UNITED STATES PATENT AND TRADEMARK OFFICE

APPLICATION NO.	FILING DATE	FIRST NAMED INVENTOR	ATTORNEY DOCKET NO.	CONFIRMATION NO.
10/780,401	02/16/2004	J. Mark Morrow	031599/260283	1618

Office Action Summary

- 1) ☒ Responsive to communication(s) filed on 13 February 2006.
- 2a) ☒ This action is **FINAL**. 2b) ☐ This action is non-final.
- 3) ☐ Since this application is in condition for allowance except for formal matters, prosecution as to the merits is closed in accordance with the practice under *Ex parte Quayle*, 1935 C.D. 11, 453 O.G. 213.

FIG. 5.

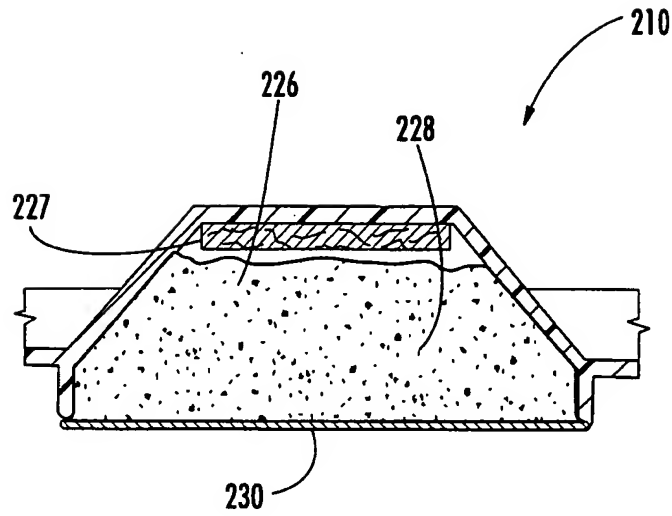
1. The new drawing (Figure 5) was received on 2/13/2006. This drawing is approved by the Examiner.

OK. TO ENTER. LRB
3/31/06
